工程指示 / 要求簡箋(E.I.)

工程指示編號：EI / 0222 / 19

工程名稱：觀塘裕民坊

工程項目：幕牆 - 安裝玻璃前和後的方案+副框

# 步驟 2

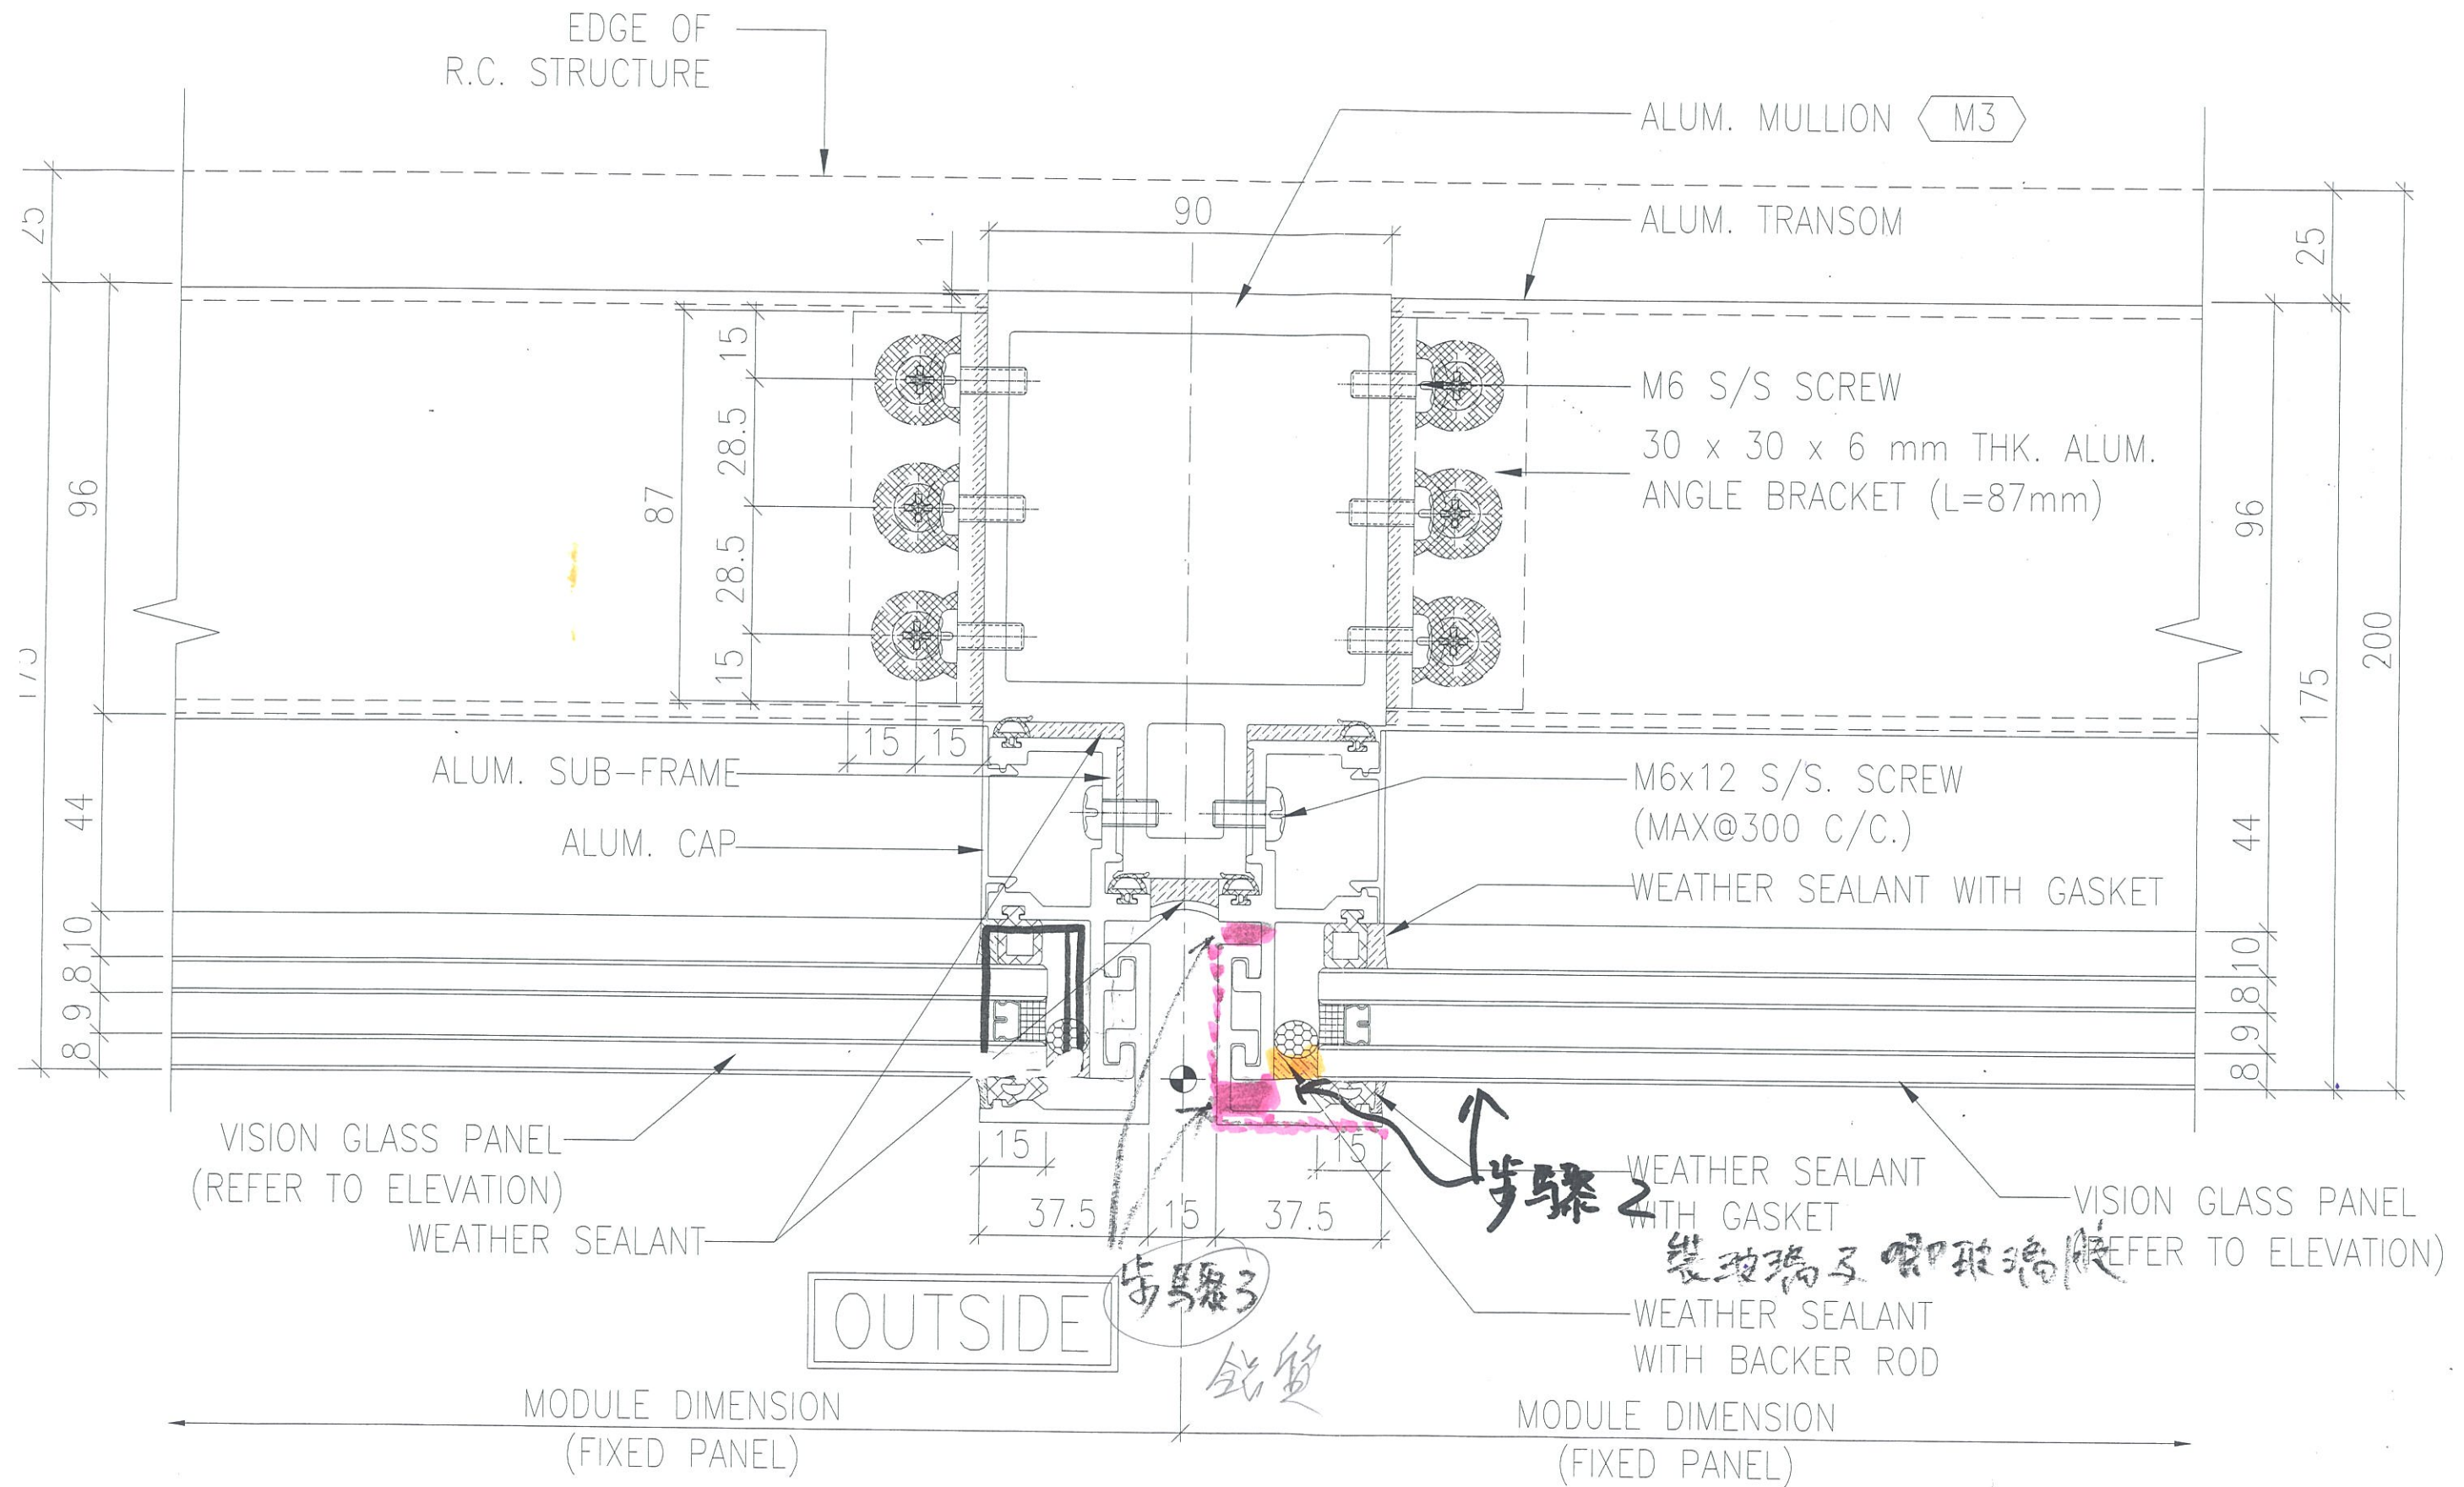
步驟 1 女唧膠拉手 (鉛質做)

3  
(左)

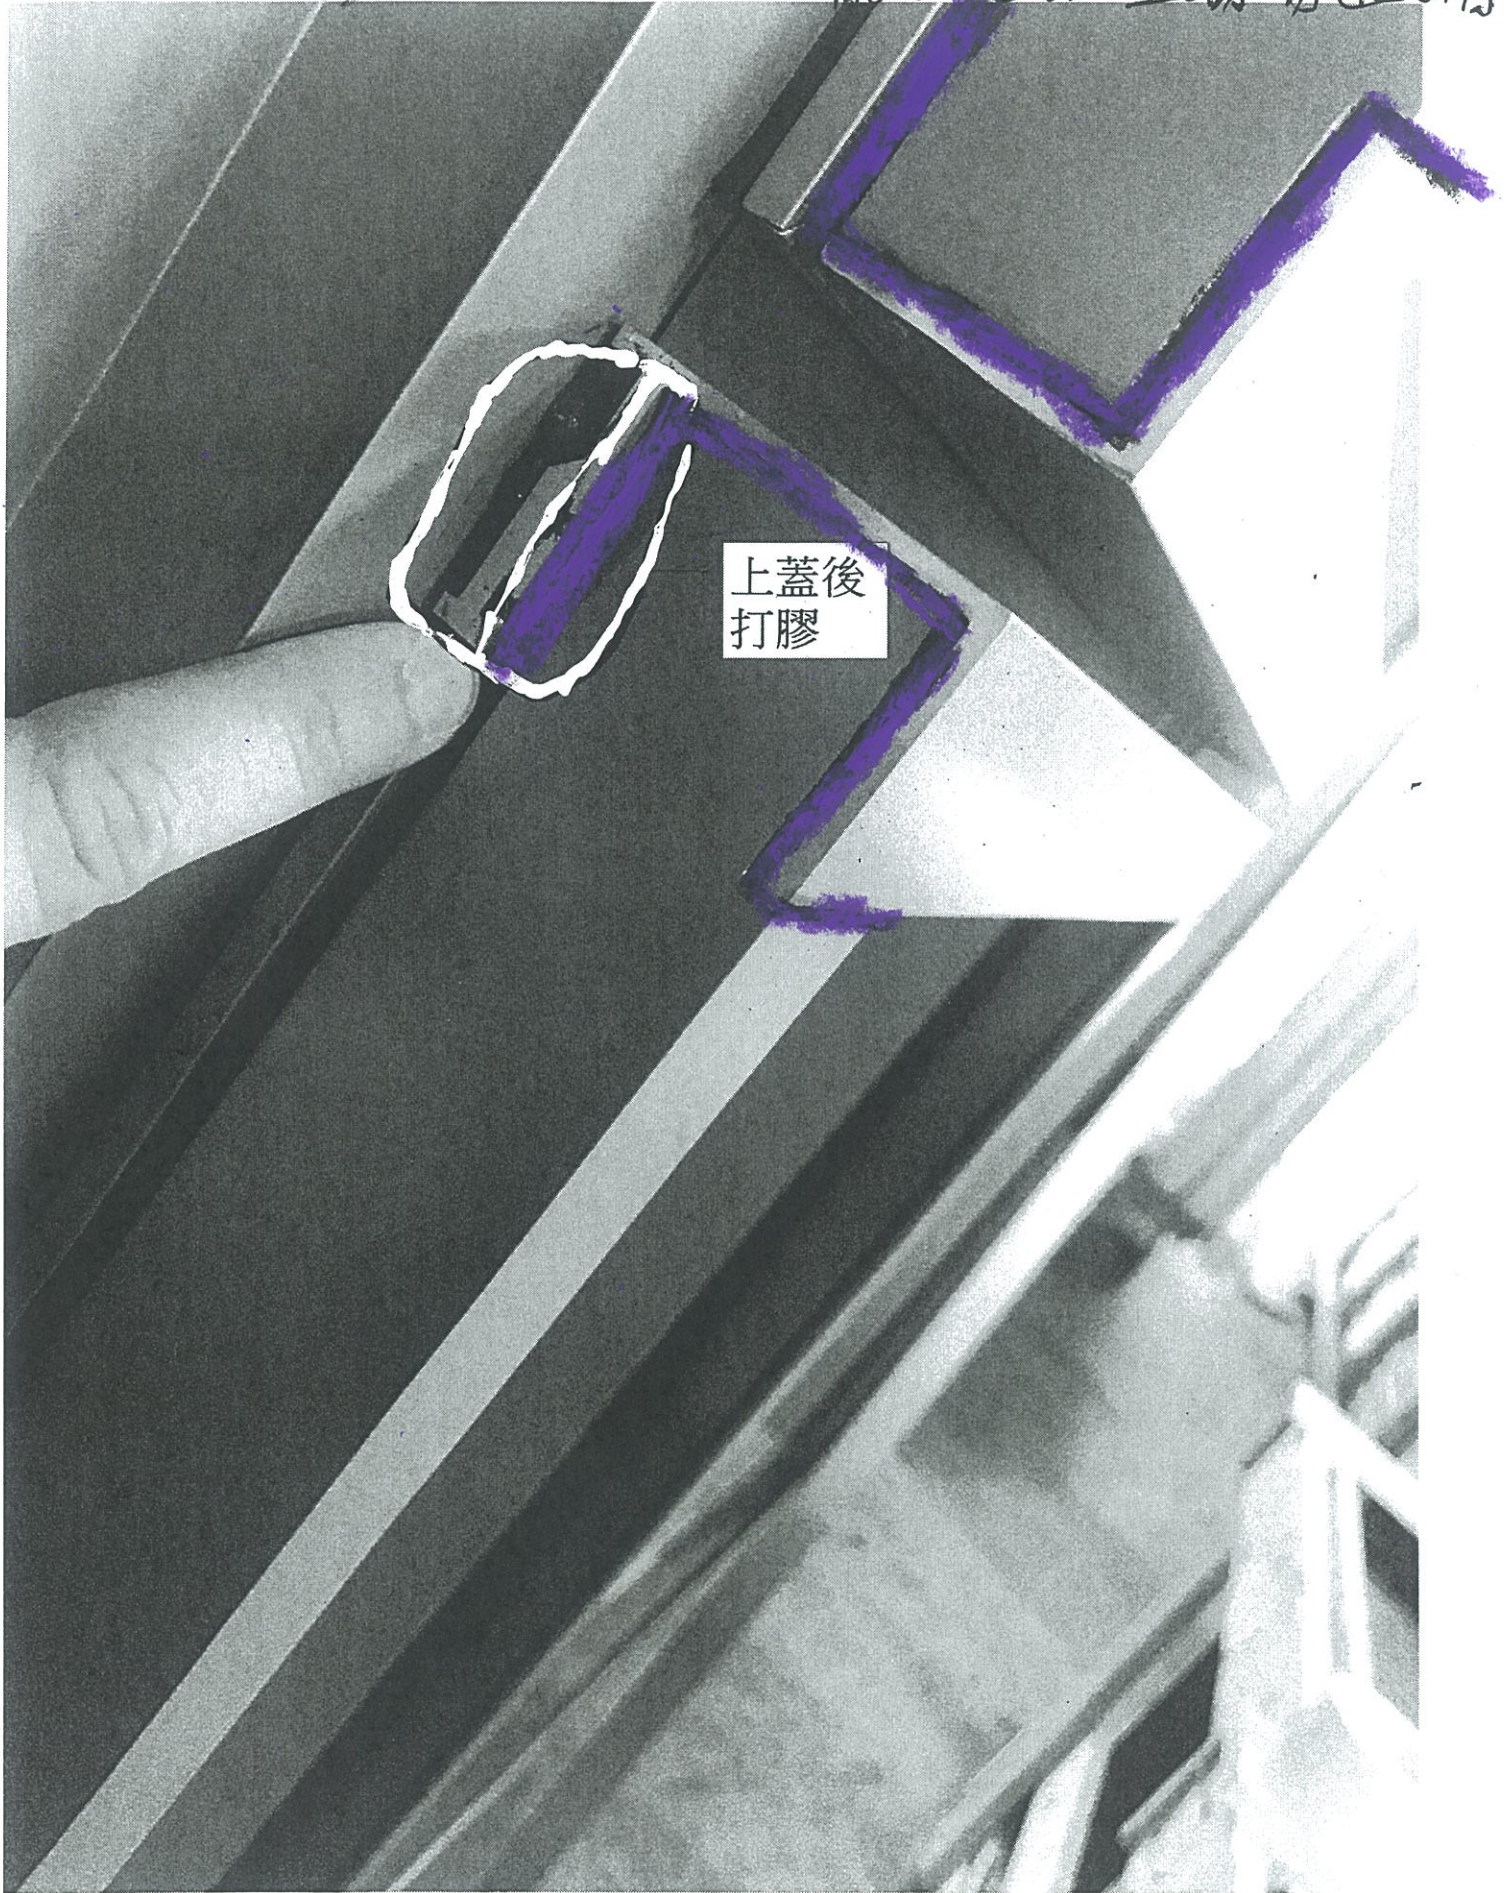
打少量膠，方便日後如需要換玻璃蓋  
能把色線蓋轉易輕拆除

上蓋後  
打膠

1 6002 TYPICAL TRANSOM DETAIL CURTAIN WALL

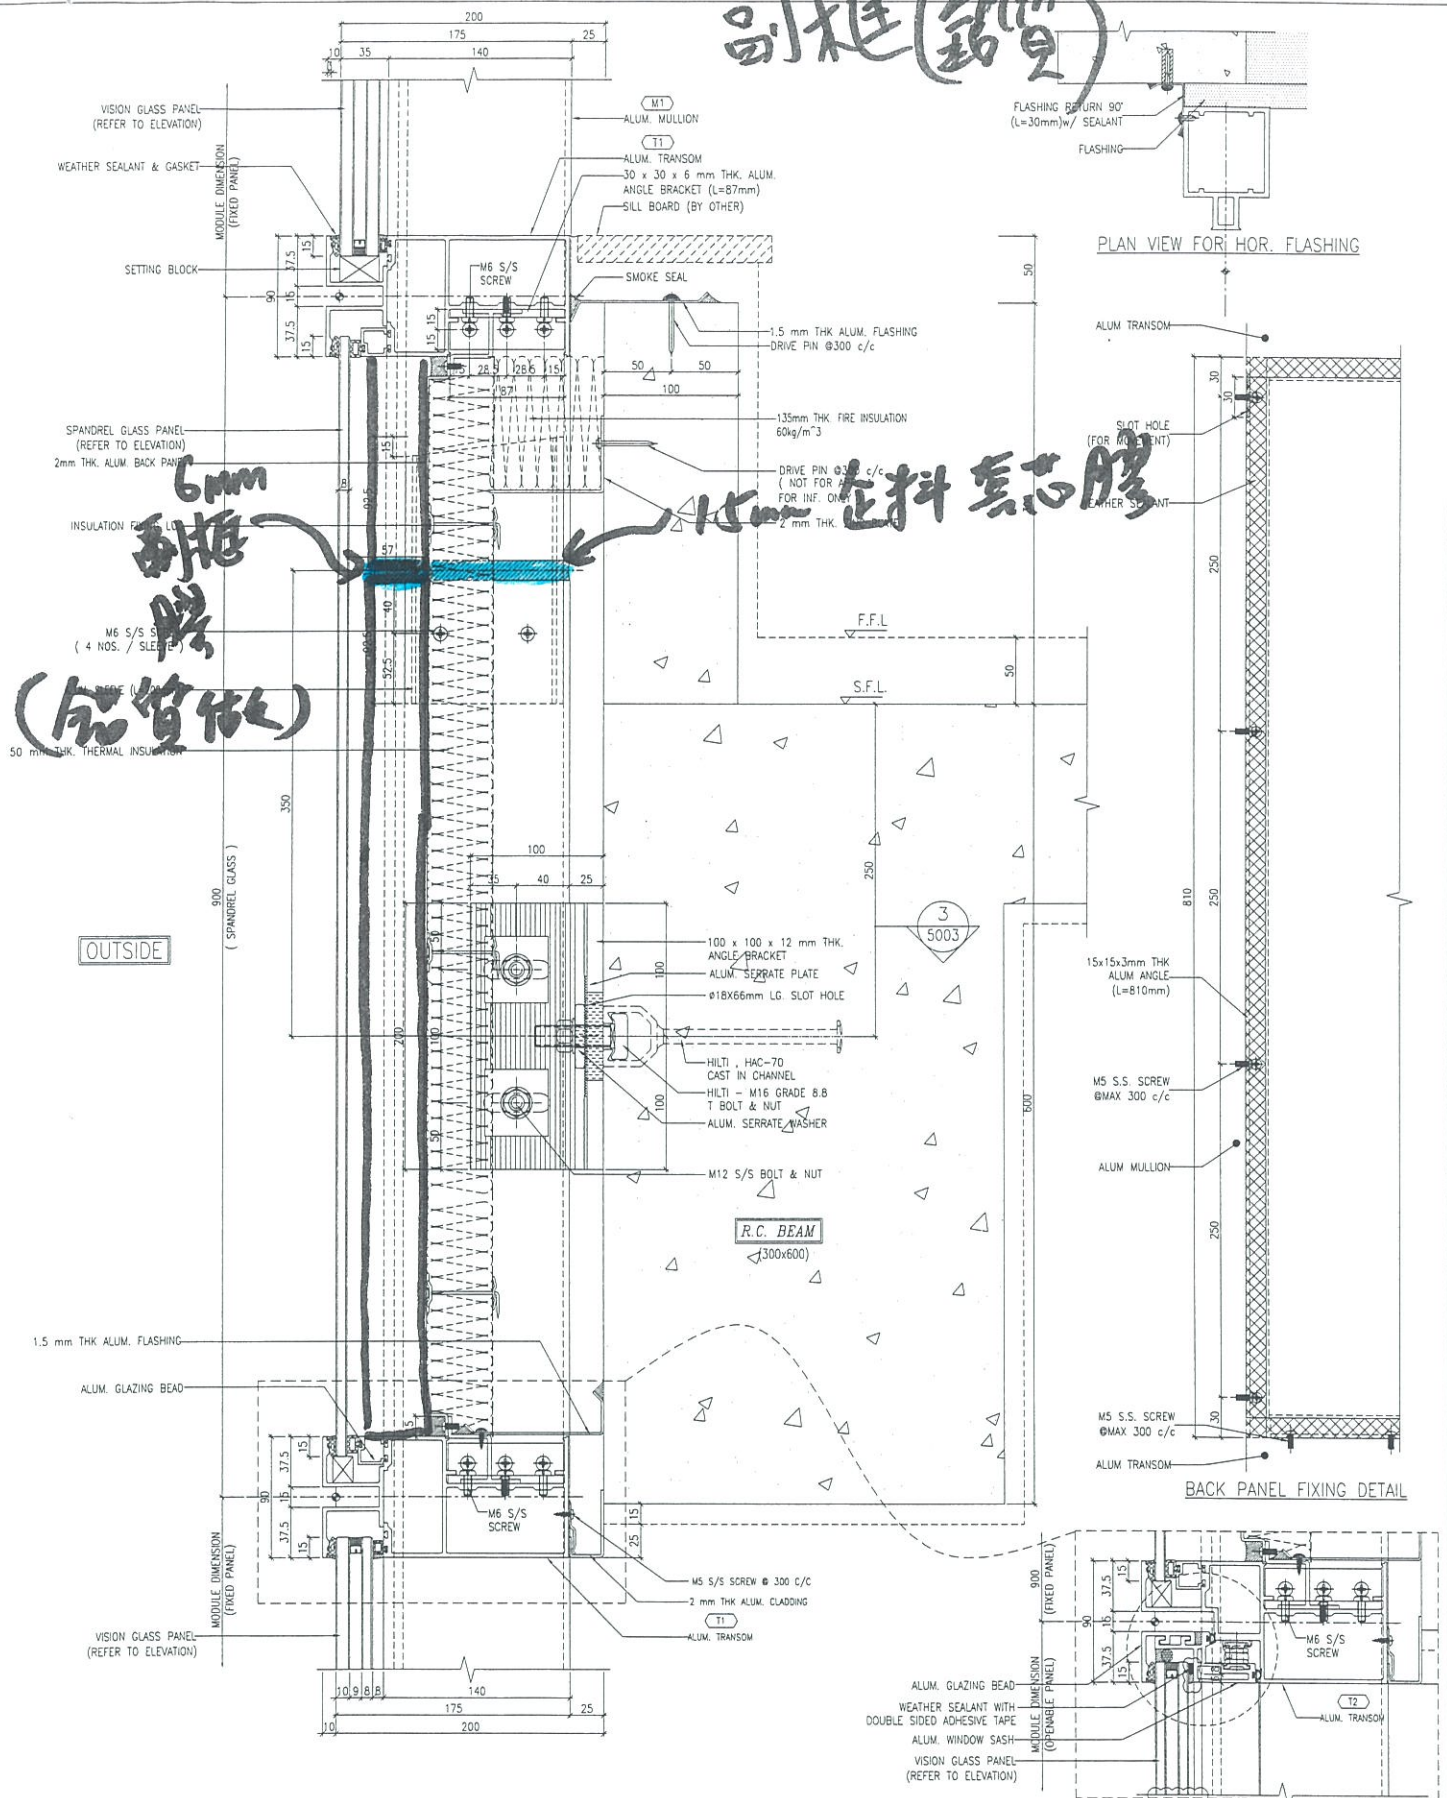
副框(鉛質)
